Thursday, January 28, 2021
10:00 am.

SUBDIVISION AUTHORITY AGENDA MEETING NO. 04

Subdivision Authority

SUBDIVISION CONDITIONS OF APPROVAL MAP

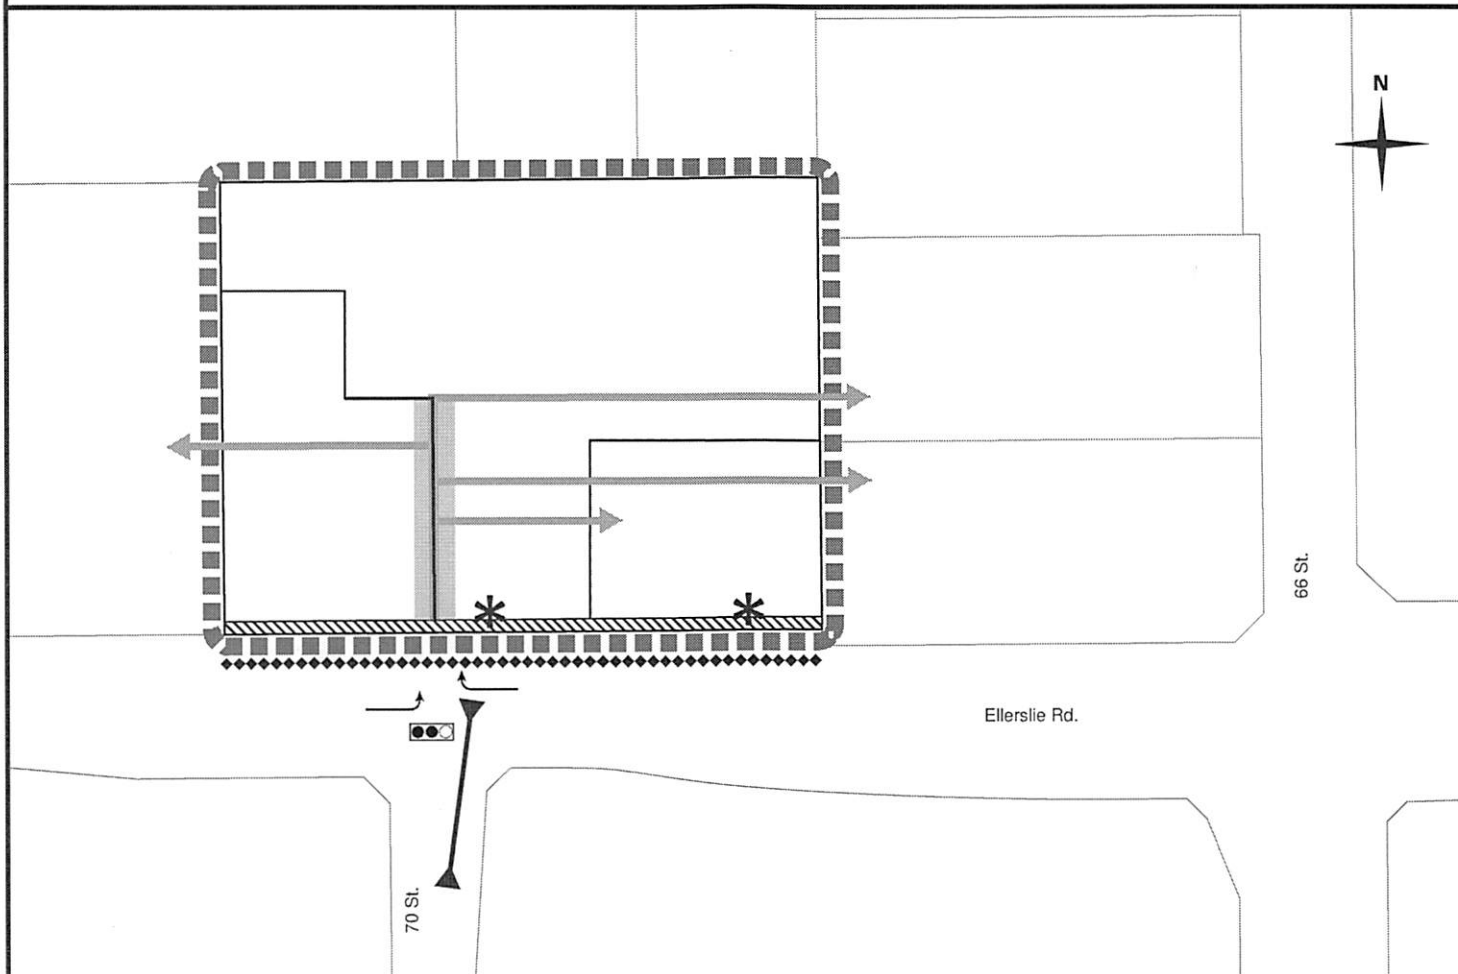
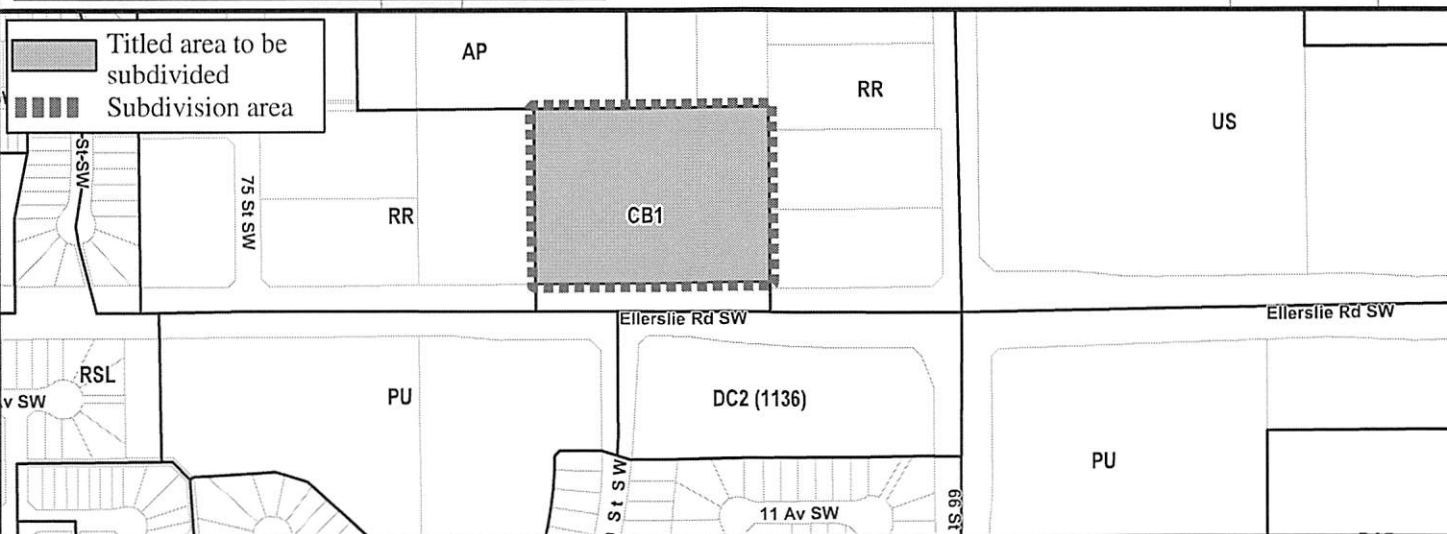
3. that the owner register an easement for mutual access as shown on the "Conditions of Approval" map, Enclosure I. The City shall be a party to the easement;

4. that the owner register an easement for cross lot access as shown on the "Conditions of Approval" map, Enclosure I. The City shall be a party to the easement;

5. that the owner dedicate, clear and level Ellerslie Road SW as required for road right of way, and said dedication shall conform to approved Preliminary Plans or to the satisfaction of Subdivision and Development Coordination, as shown on the "Conditions of Approval" map, Enclosure I; and

7. that the owner removes existing accesses to Ellerslie Road SW, to the satisfaction of Subdivision and Development Coordination, as shown on the "Conditions of Approval" map, Enclosure I;

8. that the owner constructs a westbound right turn bay with taper and an eastbound left turn bay with taper, on Ellerslie Road SW to an arterial roadway standard including channelization, access construction, intersections, lighting, landscaping and any transitional improvements, to the satisfaction of Subdivision and Development Coordination, as shown on the "Conditions of Approval" map, Enclosure I. Preliminary Plans are required to be approved for Ellerslie Road SWS prior to the approval of engineering drawings for arterial and subdivision, or to the satisfaction of Subdivision and Development Coordination;

9. that the owner constructs a 3 m hard surface shared use path within the ultimate alignment of Ellerslie Road SW, to the satisfaction of Subdivision and Development Coordination, as shown on the "Conditions of Approval" map, Enclosure I;

10. that the owner pay for the conversion/upgrade of the existing traffic signals at the intersection of Ellerslie Road SW and 70 Street SW, as shown on the "Conditions of Approval" map, Enclosure I. The City of Edmonton shall complete the signal design, and the City's Electrical Services Contractor must install the signals as per the agreement between the City of Edmonton and the Electrical Services Contractor. The timing of the traffic signals installation will be at the direction of Transportation Operations; and

11. that the owner constructs underground utilities including sanitary sewer main extension, to the satisfaction of EPCOR Water Services Inc. and Subdivision and Development Coordination, as shown on the "Conditions of Approval" map, Enclosure I.

SUBDIVISION CONDITIONS OF APPROVAL MAP

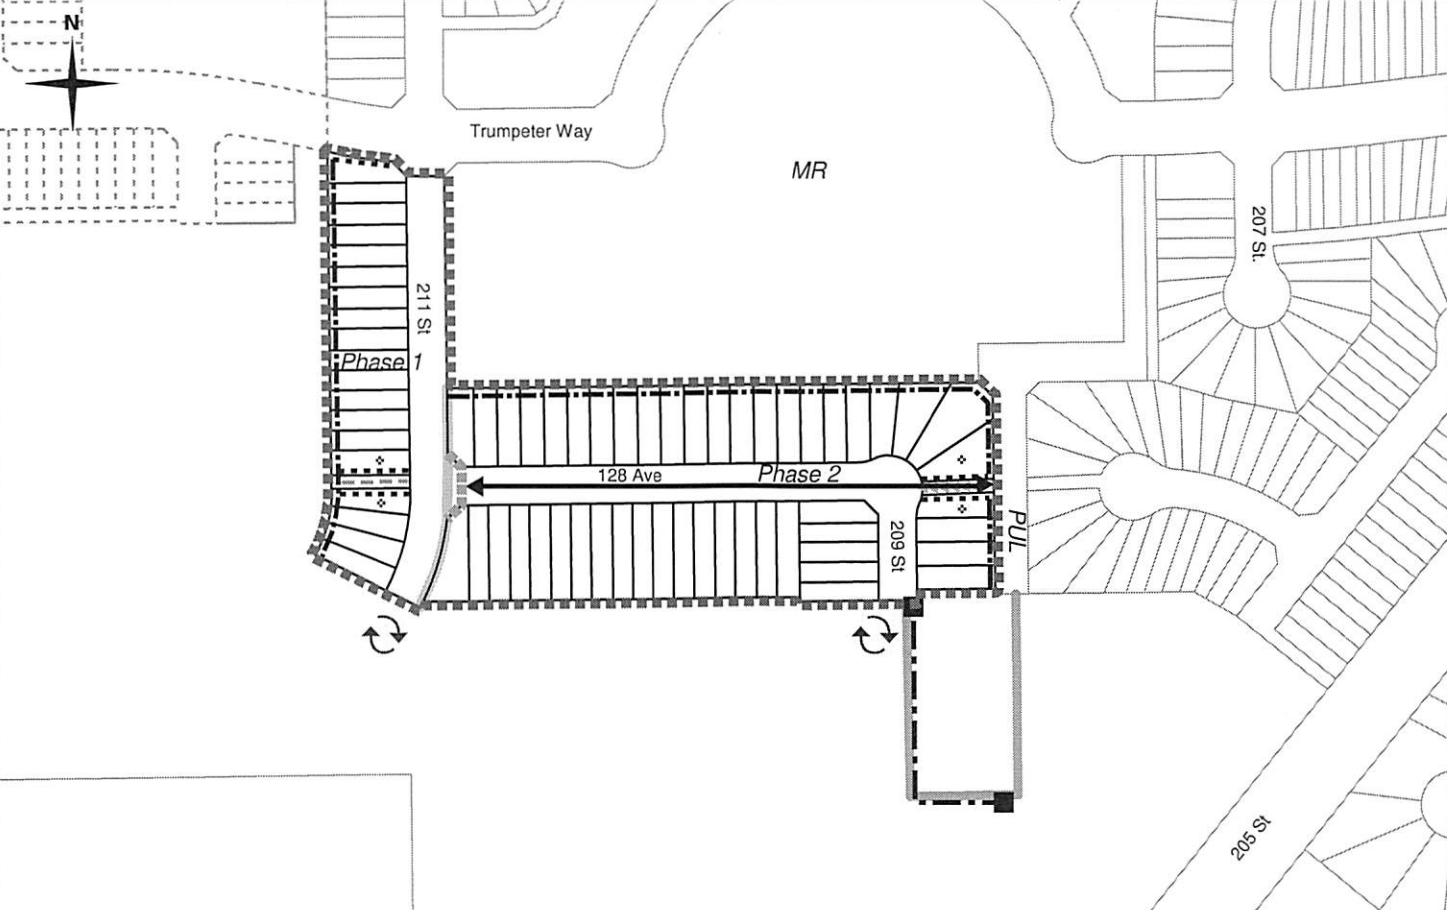
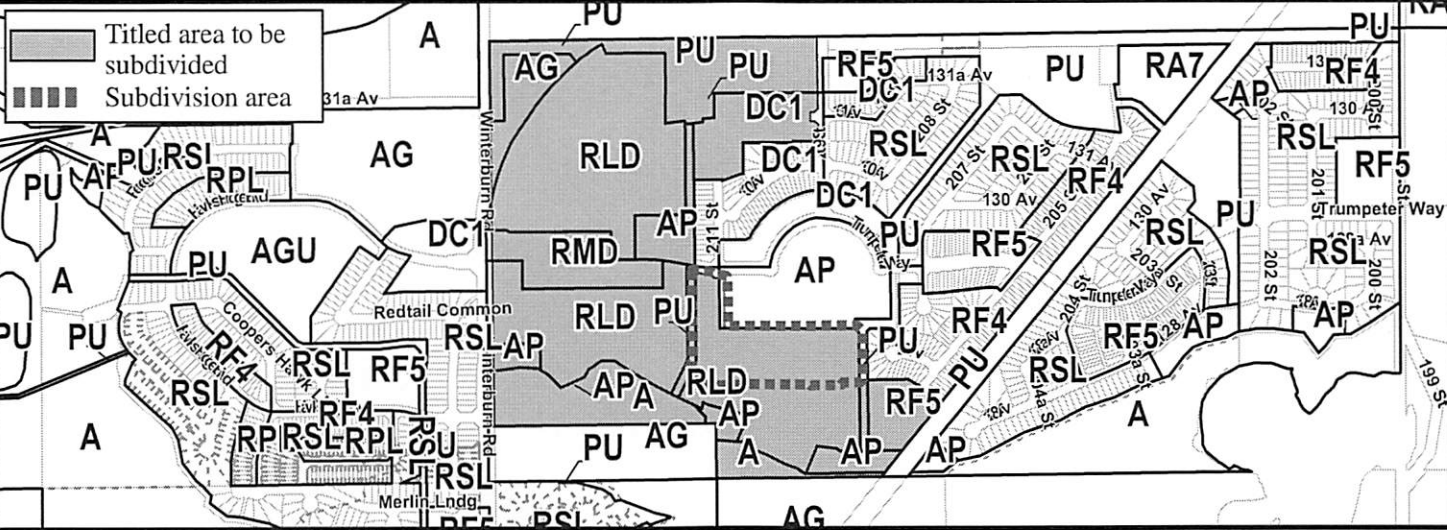
3. that the owner be permitted to register this plan of subdivision in phases in sequential order, as shown on the "Conditions of Approval" map, Enclosure I;

4. that the approved subdivisions LDA19-0457 be registered prior to or concurrent with this application;
5. that the phasing boundary be amended to include the entire intersection of 211 Street NW and 128 Avenue NW in Phase 1, to the satisfaction of Subdivision and Development Coordination, as shown on the "Conditions of Approval" map, Enclosure I;

6. that the owner register a disturbed soil restrictive covenant in favour of EPCOR Water Services Inc. and EPCOR Drainage Services, against the lots flanking the walkways as shown on the "Conditions of Approval" map, Enclosure I; and

7. that the owner constructs the temporary 12 m radius gravel surface turnarounds with bollards or mini-barriers to the satisfaction of Subdivision and Development Coordination, as shown on the "Conditions of Approval" map, Enclosure I. These turnarounds will be required prior to Construction Completion Certificate (CCC) for roads (or when required by Subdivision and Development Coordination);

8. that the owner constructs a temporary 4 m gravel surface roadway connection to the satisfaction of Subdivision and Development Coordination, as shown on the "Conditions of Approval" map, Enclosure I. This roadway will be required prior to Construction Completion Certificate (CCC) for roads (or when required by Subdivision and Development Coordination);

9. that the owner constructs a 3 m concrete emergency access walkway with lighting, and t-bollards to the satisfaction of Subdivision and Development Coordination, as shown on the "Conditions of Approval" map, Enclosure I;

10. that the owner constructs a 1.8 m concrete sidewalk with lighting, and bollards, within the walkway with connections to adjacent paths, to the satisfaction of Subdivision and Development Coordination, as shown on the "Conditions of Approval" map, Enclosure I;

11. that the owner constructs offsite storm sewers and major drainage route to connect the proposed subdivision to the existing system, to the satisfaction of Subdivision and Development Coordination, as shown on the "Conditions of Approval" map, Enclosure I;

12. that the owner construct all fences wholly on privately-owned lands, to the satisfaction of Subdivision and Development Coordination, as shown on the "Conditions of Approval" map, Enclosure I; and

TENTATIVE PLAN
SHOWING
PROPOSED SUBDIVISION
OF
LOT 6, BLOCK 13, PLAN 6074 KS
SW 1/4, SEC. 26, TWP. 52, RGE. 24, W.4M.
EDMONTON - ALBERTA

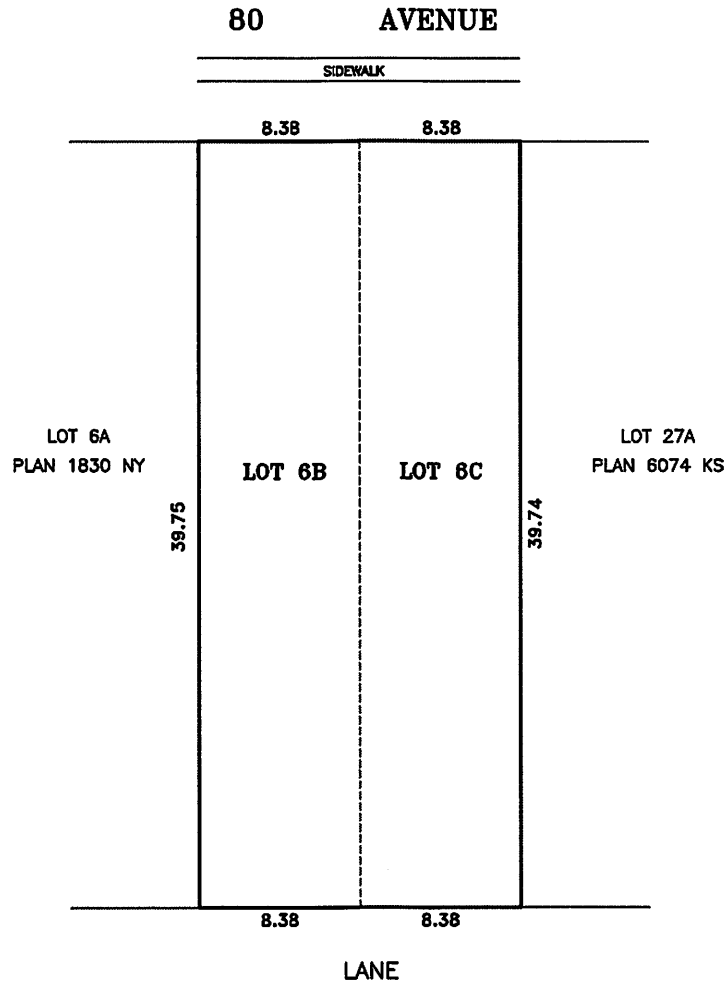
- Access for future development must be to the adjacent alley in conformance with Mature Neighbourhood Overlay Section 814.3(17) of the Zoning Bylaw #12800.
- There is an existing access to 80 Avenue NW. Upon redevelopment of proposed Lot 6C, the existing residential access to 80 Avenue NW must be removed. The owner/applicant will be required to obtain a Permit to remove the access, available from Development and Zoning Services, 2nd Floor, 10111 - 104 Avenue NW, Edmonton.

- The existing services (water and sanitary) enter the proposed subdivision approximately 6.5 m east of the west property line of existing Lot 6 off 80 Avenue NW. As per the EPCOR Drainage Services Bylaw and the EPCOR Water Services and Wastewater Treatment Bylaw, these services cannot cross the proposed property line.

- There is a deficiency in on-street fire protection adjacent to the property. The applicant/owner is advised to review on-site fire protection requirements to ensure adequate coverage (contact EPCOR Water at 780-412-3955).

TENTATIVE PLAN
 SHOWING PROPOSED SUBDIVISION OF
 LOT 3 BLOCK 1, PLAN 3131KS
 WITHIN
 (S.W. 1/4 SEC. 22 - TWP. 52 - RGE. 24 - W. 4th MER.)
 CORONET ADDITION INDUSTRIAL
 EDMONTON, ALBERTA
 SCALE: 1:500

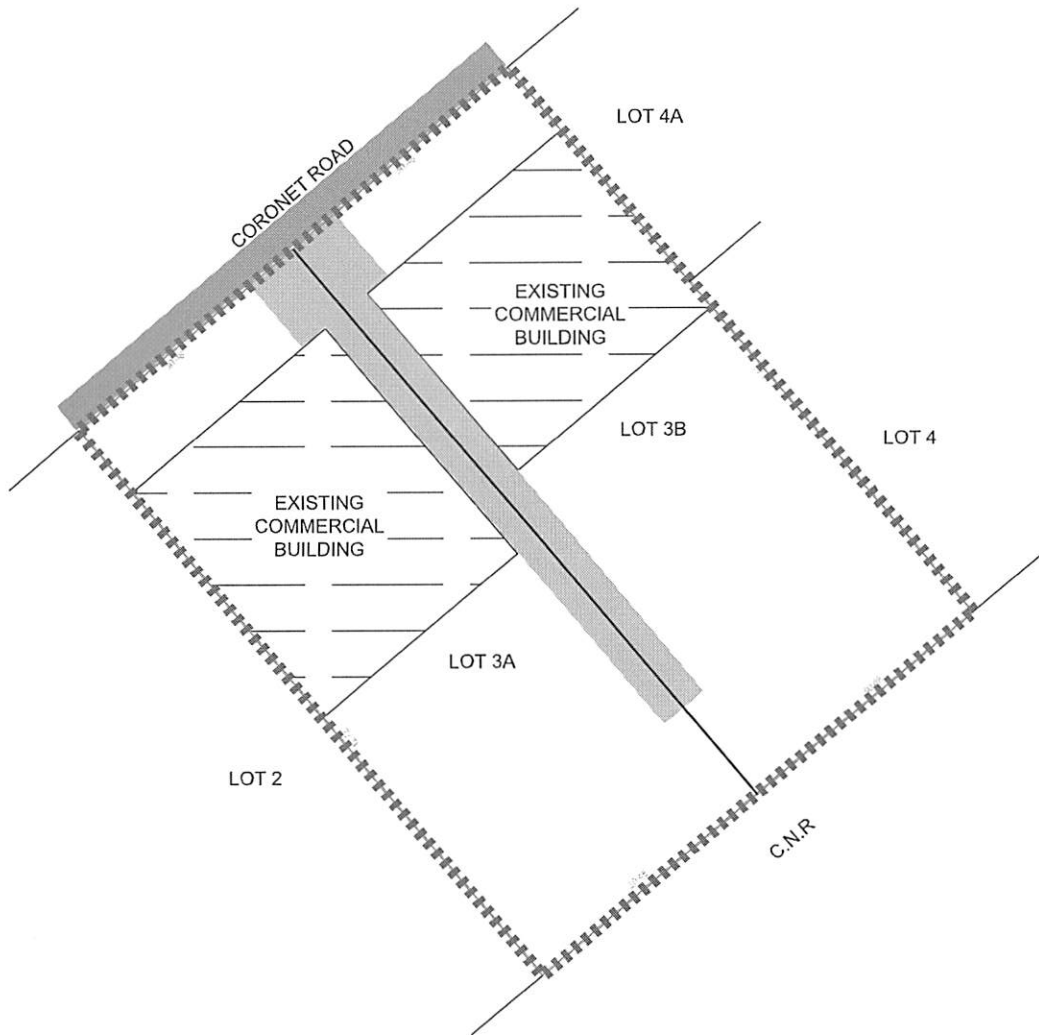
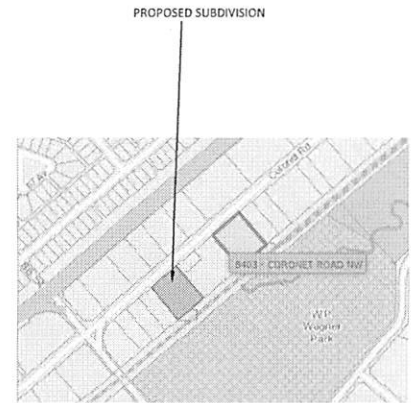
1. that the owner enter into a Servicing Agreement with the City of Edmonton for the payment of the applicable Permanent Area Contributions, pursuant to Section 655 of the Municipal Government Act (contact development.coordination@edmonton.ca);
2. that the owner register an easement for mutual access, as shown on the "Conditions of Approval" map, Enclosure I. The City shall be a party to the easement;
3. that the owner apply for a License of Occupation to authorize the ongoing use of road right-of-way for additional parking, as shown on the "Conditions of Approval" map, Enclosure I (see www.edmonton.ca/business_economy/road-rights-of-way.aspx); and
4. that the owner pay all outstanding property taxes prior to the endorsement of the plan of survey.

- The existing services (water, sanitary, and storm) enter proposed Lot 3A approximately 43.4 m west of the east property line of Lot 3, off of Coronet Road NW. The existing services (water, sanitary, and storm) enter proposed Lot 3B approximately 19.4 m east of the east property line of Lot 3, off of Coronet Road NW. As per the EPCOR Drainage Services Bylaw and the EPCOR Water Services and Wastewater Treatment Bylaw, these services cannot cross the proposed property line.

- There is a deficiency in on-street hydrant spacing adjacent to the property. The applicant/owner is advised to review on-site fire protection requirements to ensure adequate coverage (contact EPCOR Water at 780-412-3955).

GLENORA
TENTATIVE PLAN SHOWING PROPOSED
SUBDIVISION
OF
LOTS 2 & 3, BLOCK 59, PLAN 3875 P
WITHIN
RIVER LOT 2 (THEO. TWP. 53 - RGE. 25 - W. 4TH MER.)
EDMONTON - ALBERTA

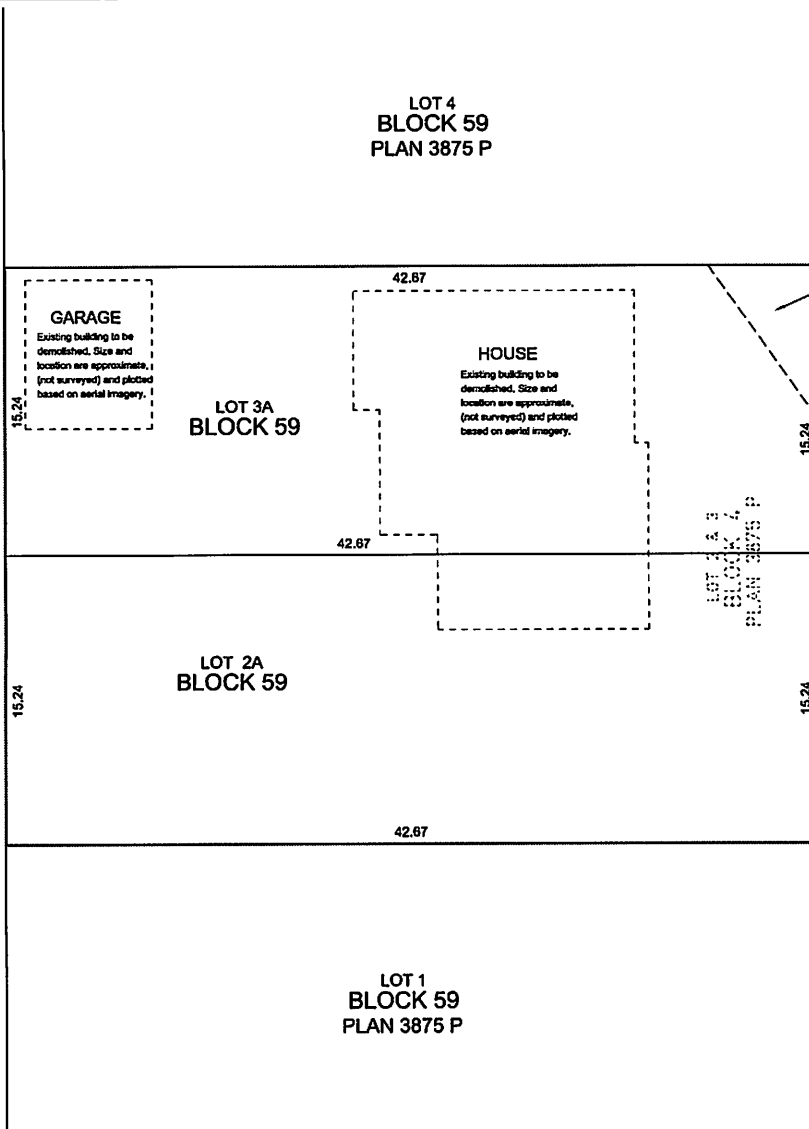
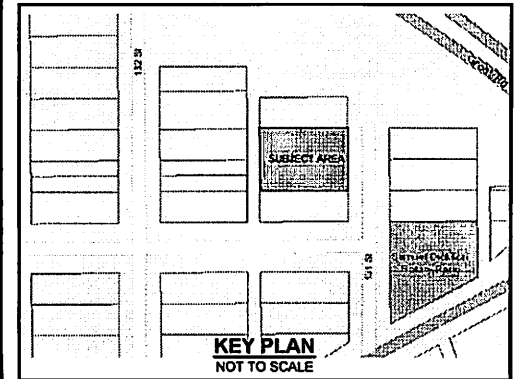
- There are existing boulevard trees adjacent to the site on 131 Street NW that must be protected during construction. For information about tree protection please refer to the City of Edmonton's website (Trees and Construction).
- Access for future development must be to the adjacent alley in conformance with Mature Neighbourhood Overlay Section 814.3(17) of the Zoning Bylaw #12800.
- There is an existing power pole in the alley. Site access must maintain a minimum clearance of 1 m from the closest edge of the power pole to the closest edge of the proposed driveway.

- The existing services (water and sanitary) enter the proposed subdivision approximately 8.3 m south of the north property line of existing Lot 3 off of the lane. As per the EPCOR Drainage Services Bylaw and the EPCOR Water Services and Wastewater Treatment Bylaw, these services cannot cross the proposed property line.
